## Response to RC1:

Authors: Xuanye Zhang, Hailong Yang, Lingbing Bu, Zengchang Fan, Wei Xiao, Binglong Chen, Lu Zhang, Sihan Liu, Zhongting Wang, Jiqiao Liu, Weibiao Chen and Xuhui Lee

This paper presents a comprehensive analysis of XCO<sub>2</sub> observations obtained in the vicinity of coal-fired power plants using the ACDL spaceborne instruments on board the DQ-1 satellite. Leveraging the integrated differential absorption (IPDA) lidar technique, the work utilizes these data to derive emission fluxes and compare them against existing inventories.

Figure 3: Typical daytime and nighttime DQ-1 overpasses around the Reftinskaya GRES power station, with the red six-pointed star indicating the location of the power station and the arrow representing the wind direction at the plume.

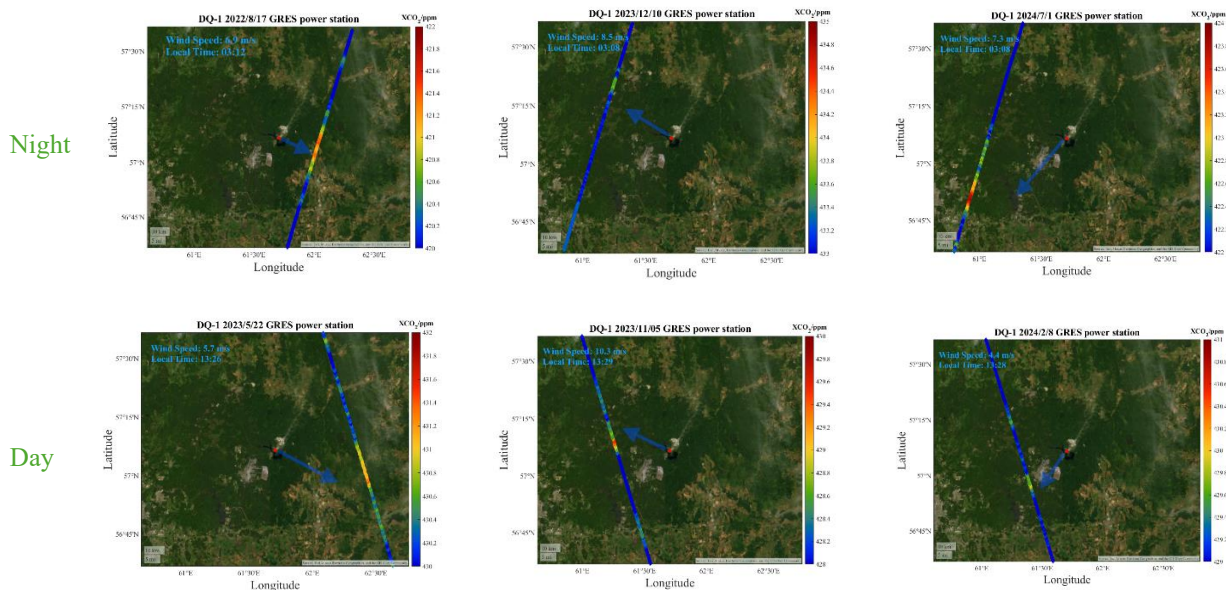
24. Figure 3: Please increase the figures and labels for better readability. It might be more instructive to show the overpasses in the same map cutout and scale. Is there a significance in the size of the wind arrows? I suggest to provide approximate wind speed information and local time of overpass. Probably it makes no sense to apply the same scale to all graphs due to different background values, but at least the same spread (2 ppm?) should be applied to all figures.

Answer: Thanks for your suggestion. We have modified the figure 3 as you suggested. The size of the wind direction arrow is meaningless; the arrow point indicates the wind direction after interpolation of the ERA-5 data.

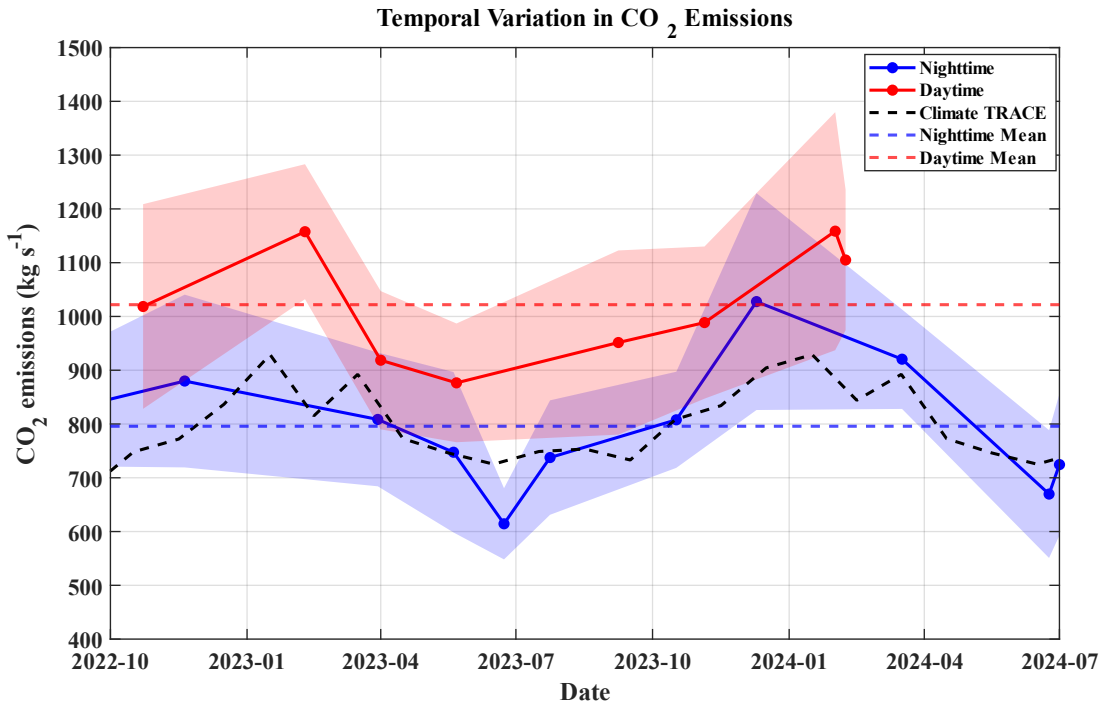
27. Figure 7: Climate Trace (not Change?); The reader may think that this is continuous data, but the lines consist of 7? individual daytime and 9? nighttime observations. Please plot the data points!

Answer: Thanks for your comments, at the time the article was submitted, ClimateTRACE had not yet published the monthly resolution data, and so far, the official website has provided monthly emissions data up to November 2024 for each power plant. I have modified this graph, and labelled the data points as requested.

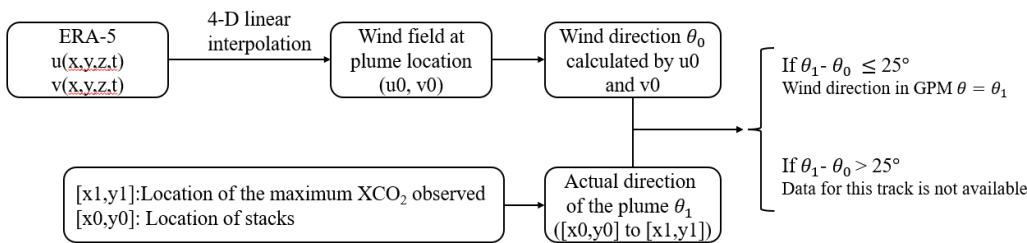
Section 2.1.2: It's not clear how the wind data is being created here. Are you using the full 3D winds and interpolating them to 240 + 250m? You mention the use of "ground-level" winds, but I'm not sure if you mean the surface or the planetary boundary layer. Perhaps a figure would be helpful to show how you use the model fields to create the steady state wind value for the GP model. Models are also notoriously bad at nighttime PBL depths. Did you evaluate these wind fields against any atmospheric data, especially at night?

Answer: Thanks for your suggestions! The high-altitude wind data mentioned here, with reference to Nassar et al. (Nassar et al., 2021), directly interpolates the three-dimensional wind field of ERA-5 to the height of 240+250 m. The ground winds here are surface winds(2-m), which I may not have expressed very clearly, and have been modified to the surface 2 m wind speeds, which are mainly for the subsequent calculations of the parameters of atmospheric instability. We have revised in Line 123: “In this study, atmospheric instability is calculated from surface wind speeds and cloud cover, with surface wind speed data selected from spatially interpolated ERA5-land hourly wind speed U and V vectors.”

The specific three-bit wind field interpolation method can be divided into two steps, the specific method is shown in the following figure:
